Technical Memorandum

To: Ann Foss, Minnesota Pollution Control Agency; Jess Richards, Minnesota Department of Natural Resources; Kenton Spading, U.S. Army Corps of Engineers
Prepared for: Poly Met Mining, Inc.
From: Don E. Richard, PhD, P.E.
Subject: Proposed Waste Water Treatment System (WWTS) Relocations (Version 3)
Date: April 11, 2017
c: Jennifer Saran, Christie Kearney, PolyMet

Subject: Proposed Waste Water Treatment System (WWTS) Relocations (Version 3)

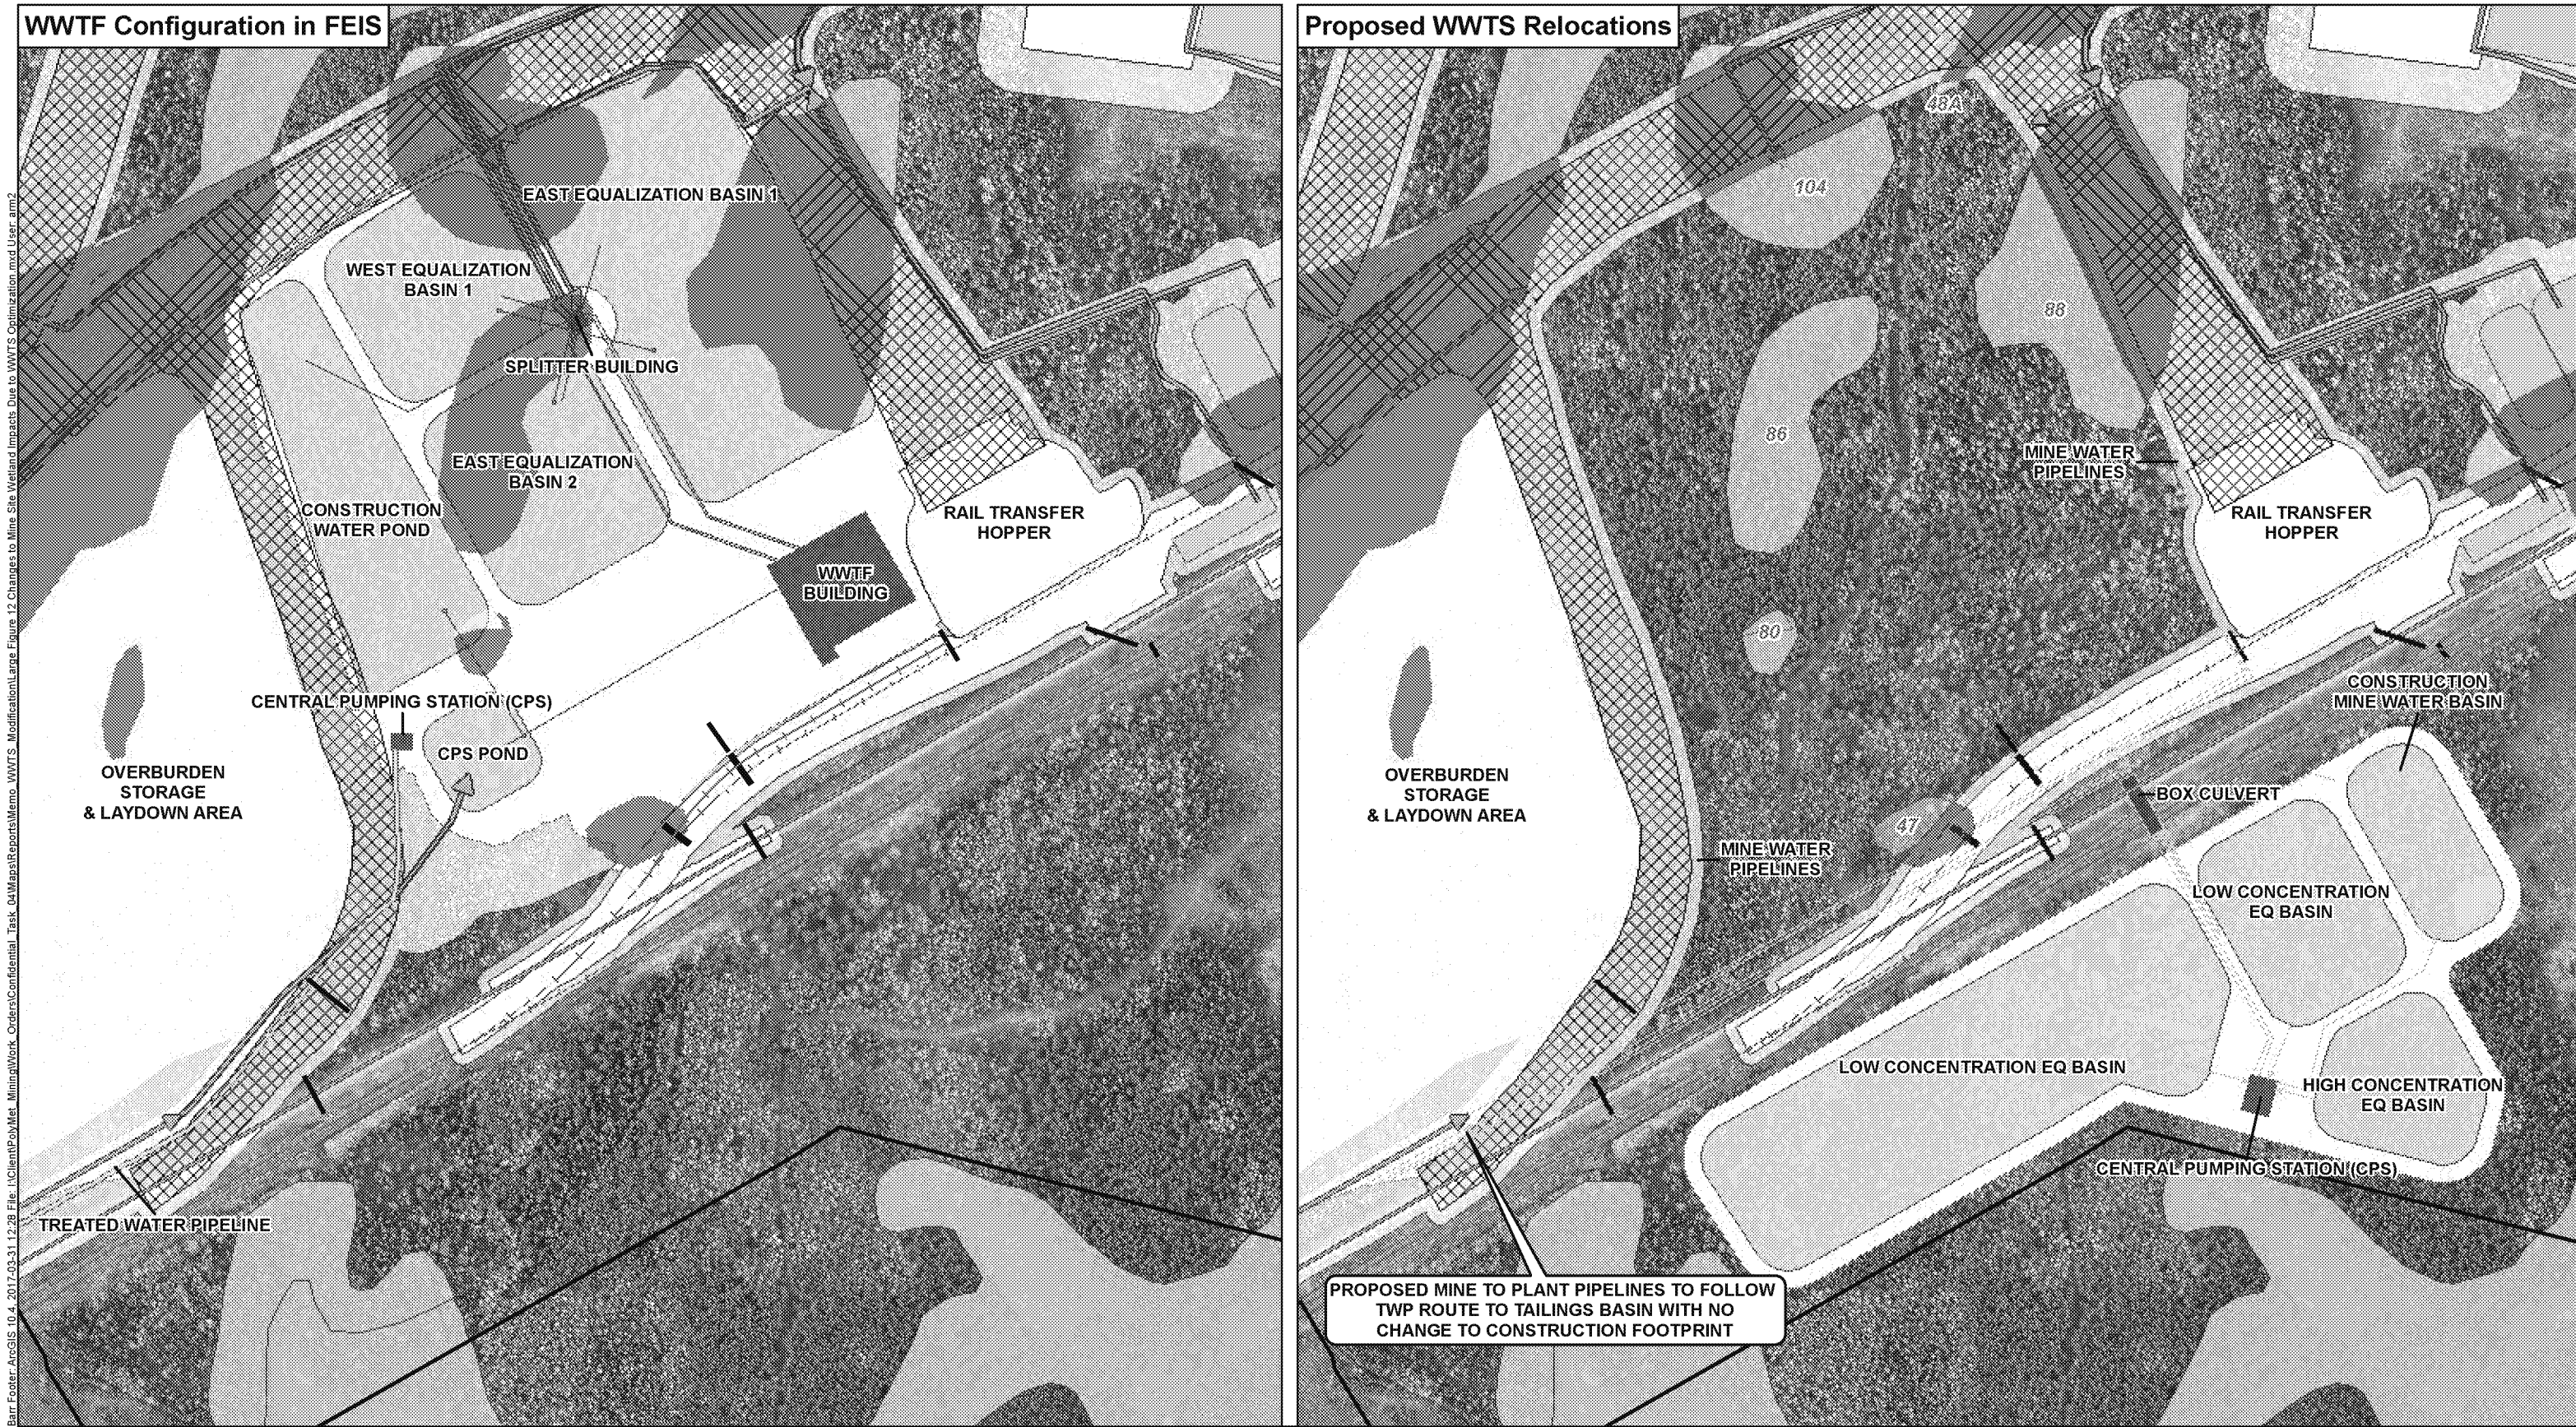
Large Figure 12 compares the wetland area impacts for the WWTS relocations to those that were included in the FEIS, Section 404 permit application, Permit to Mine application, and WCA permit application. The NorthMet Project Wetland Replacement Plan and Wetland Permit Application include the mitigation proposed for the 7.9 acres of wetland impact for the FEIS/permit application location. The wetland impacts planned in the FEIS and permit applications would include open bog, coniferous swamp, and coniferous bog. Mitigation requirements were dependent on the acreage of each type of wetland impacted. This reduction in required mitigation would be accounted for as appropriate under the applicable regulatory processes governing federal and state wetland and water permits.
